Service Bulletin No. 388B

MODEL D Series Coaches	TYPE Field Change Program	SECTION/GROUP 7 – Electrical	DATE
SUBJECT INTERIOR LED LIGHTS			
CONDITIONS

THIS BULLETIN SUPERSEDES SERVICE BULLETIN 388 IN ITS ENTIRETY.

Figure 3.

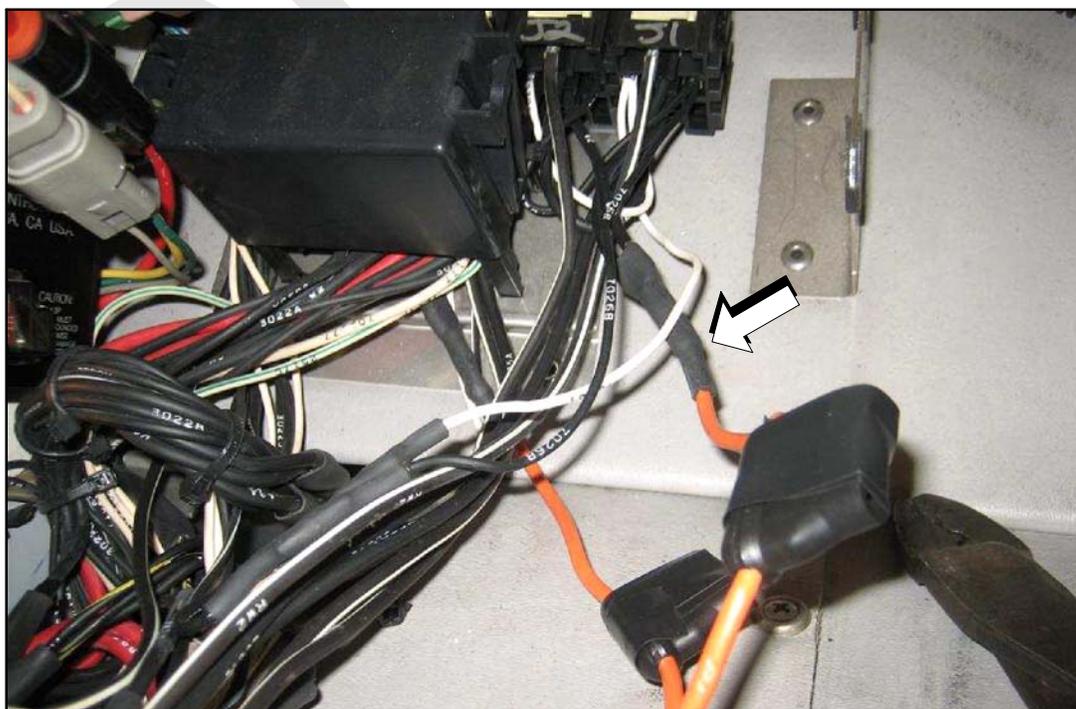
- 7. Locate the fuse holders (refer to Figure 3). Using wire cutters, cut the wires at the wire splice.

Figure 4.

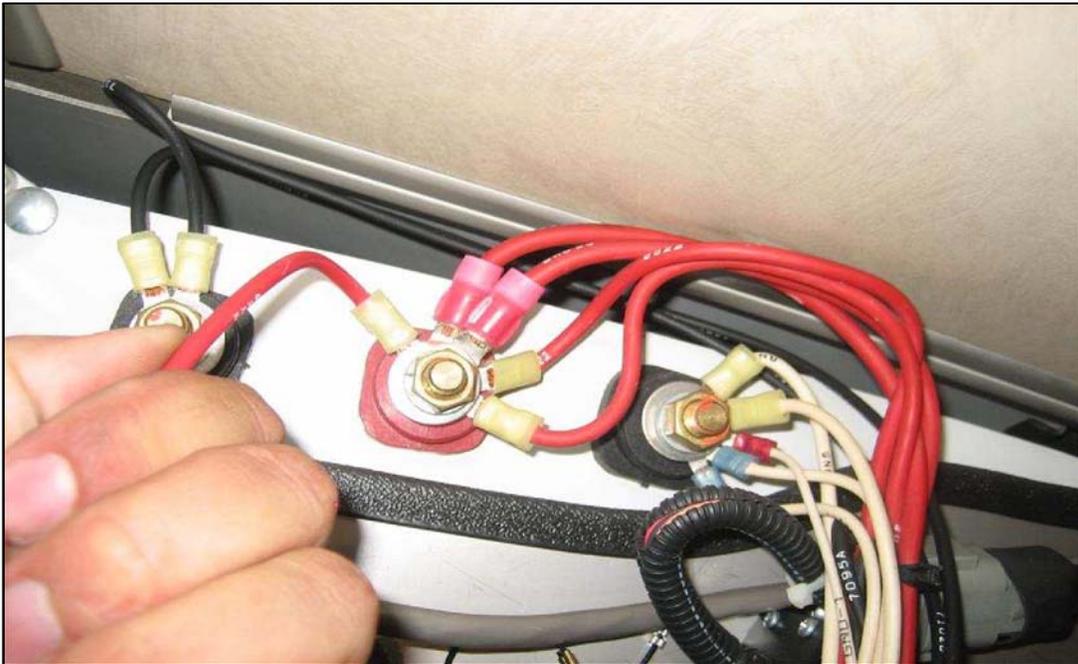
- Trace the routing of the red wire cut at the wire splice to the 24 VDC red stud block. Remove and retain the nut. Remove and discard the red wire. Return the nut to the stud block.

Figure 6. Connector S102 (splice clip connector design / brown color).

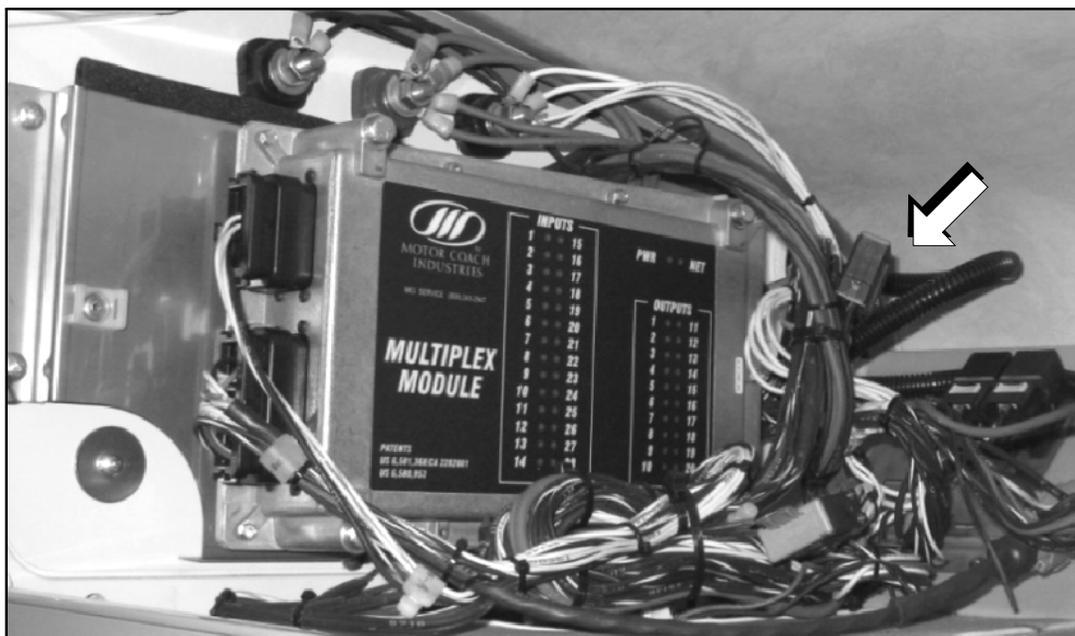
9. Locate connector S102 (refer to Figures 5 and 6).

10. Locate circuits A1, RA1 and LA1C in connector S102 cavities E, D and F. Using wire cutters, cut the wires 0.50 inch from the connector and splice them together using heat shrink, p/n 07-08-4684 (see Figure 7).

11. Locate circuits W1, RW1 and LW1C in connector S102 cavities L, K and M. Using wire cutters, cut the wires 0.50 inch from the connector and splice together using heat shrink, p/n 07-08-4684. (refer to Figure 7).

Figure 7.

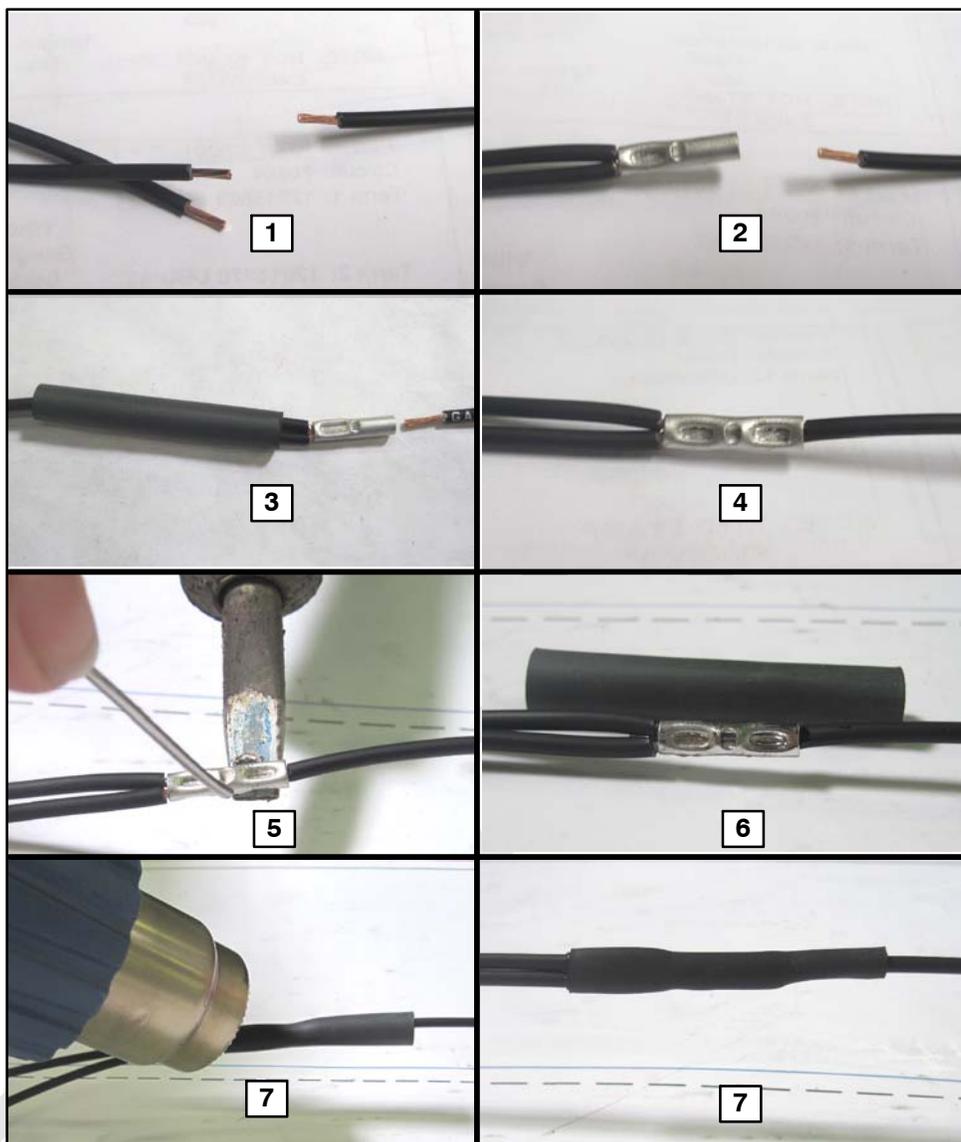
12. Using a small removal tool, remove circuit LW2A from connector S102 cavity J and splice with circuit LW2A from the Interior Light Relay Kit, p/n 07-08-4682B using heat shrink, p/n 07-08-4685 (refer to Figure 7).

13. Remove circuit RW2 from connector S102 cavity G and splice with circuit RW2 from the Interior Light Relay Kit, p/n 07-08-4682B, using heat shrink p/n 07-08-4685 (refer to Figure 7).

14. Remove circuit LA3A from connector S102 cavity C and splice with circuit LA3A from the Interior Light Relay Kit, p/n 07-08-4682B, using heat shrink p/n 07-08-4685 (refer to Figure 7).

15. Remove circuit RA3A from connector S102 cavity A and splice with circuit RA3A from the Interior Light Relay Kit, p/n 07-08-4682B, using heat shrink p/n 07-08-4685 (refer to Figure 7).

16. Discard the connector S102.

Figure 8. Relay J location in curbside, parcel rack compartment #1.

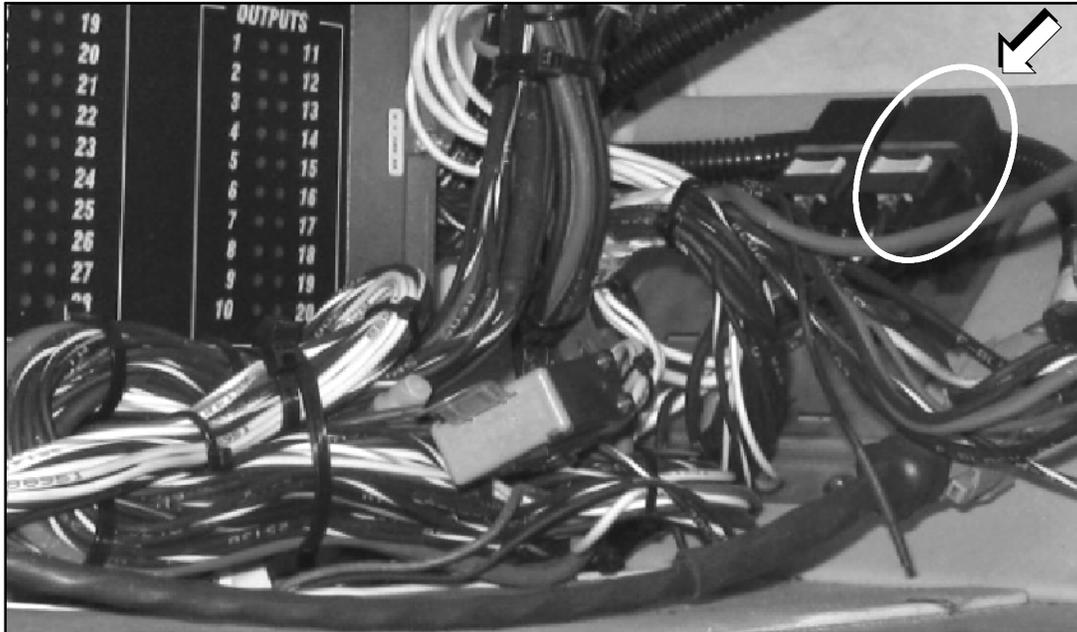
17. Locate Relay J (refer to Figure 8). Remove circuit 7026B from Relay J cavity 86 and splice with circuit 7026B from the Interior Light Relay Kit, p/n 07-08-4682B, using heatshrink, p/n 07-08-4684.
18. Remove circuit 70261 from Relay J cavity 85 and splice with circuit 70261 from the Interior Light Relay Kit, p/n 07-08-4682B, using heatshrink, p/n 07-08-4684.
19. Discard Relay J and its base. Using wire cutters, cut and remove any other wire connected to the relay.

Figure 9. Relay K location in curbside, parcel rack compartment #1.

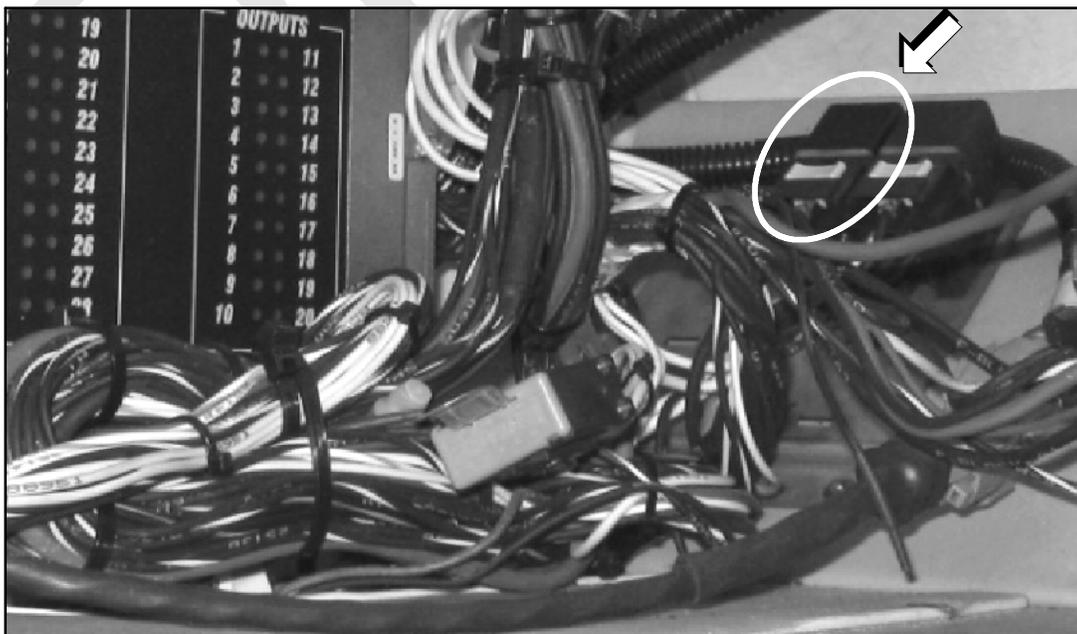
20. Locate Relay K (refer to Figure 9). Remove circuit 7029 from Relay K cavity 86 and splice with circuit 7029 from the Interior Light Relay Kit, p/n 07-08-4682B, using heatshrink, p/n 07-08-4684.
21. Remove circuit 70291 from Relay K cavity 85 and splice with circuit 70291 from relay kit (07-08-4682B) using 07-08-4684.
22. Discard Relay K and its base. Using wire cutters, cut and remove any other wire connected to the relay.

Figure 10. Fuse block in curbside, parcel rack compartment #1.

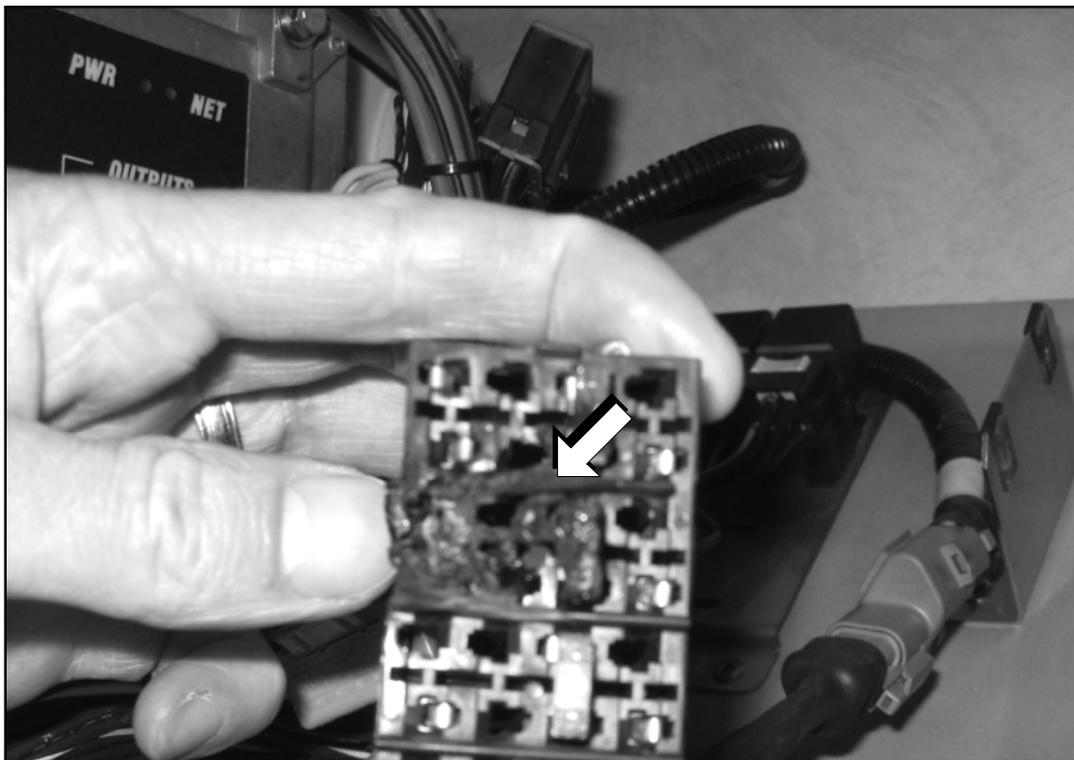
Upon visual inspection, if the fuse block exhibits signs of heat damage or melting, contact the MCI Fleet Support Technical Center at 1-800-241-2947 for further information and replacement parts.

23. Visually inspect the fuse block for heat damage or melting at locations A1 and A2 (refer to Figure 10).

Figure 11.

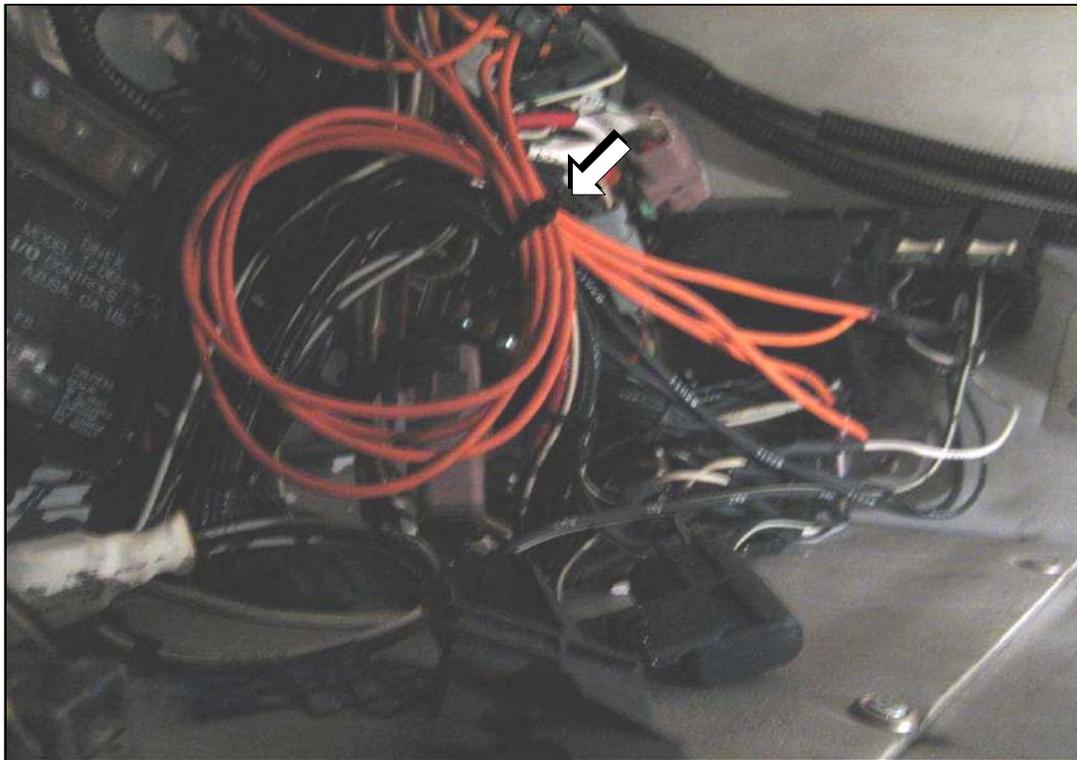
24. Using the screw, p/n19-1-640, secure Relays J1, J2, K1, K2 from the Interior Light Relay Kit to the bracket.
25. Secure circuit 8822 from the Interior Light Relay Kit to the 24V power stud.
26. Secure circuit 7095A from the Interior Light Relay Kit to the instating light stud.

27. Secure the harness installation using tytraps, p/n 19-11-258.

Figure 12. Decal legend location on junction box cover in curbside, parcel rack compartment #1.

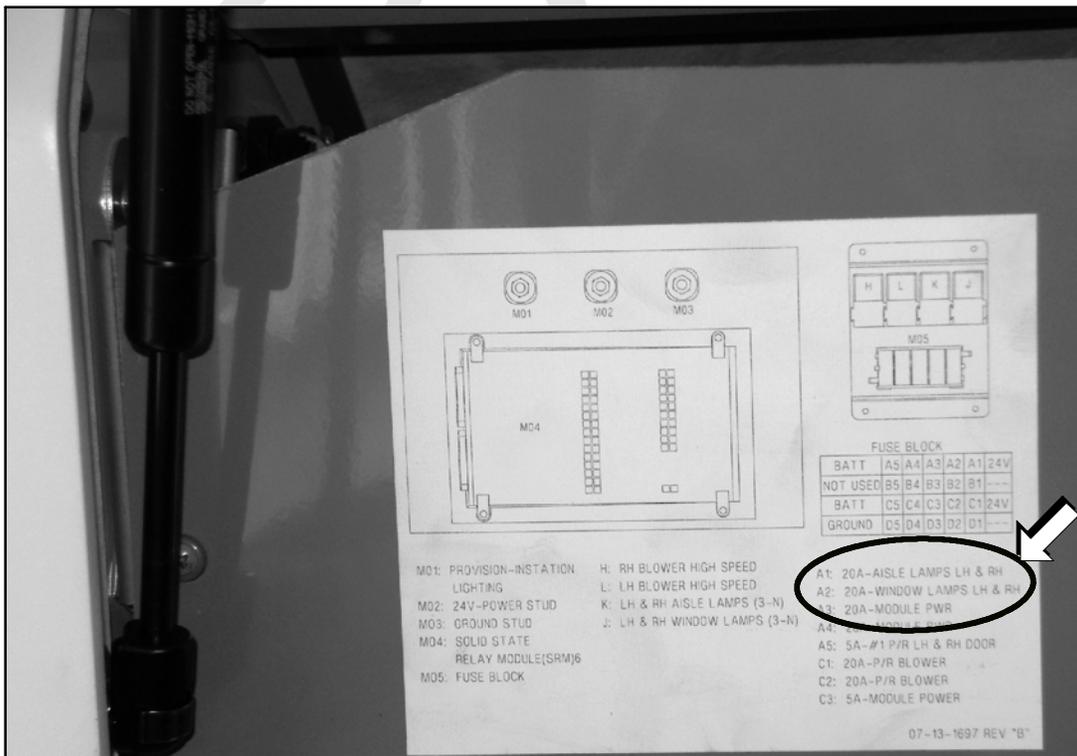
29. Using the decals, p/n 07-08-4682B, cover locations A1 and A2 on the Decal legend affixed to the junction box cover.
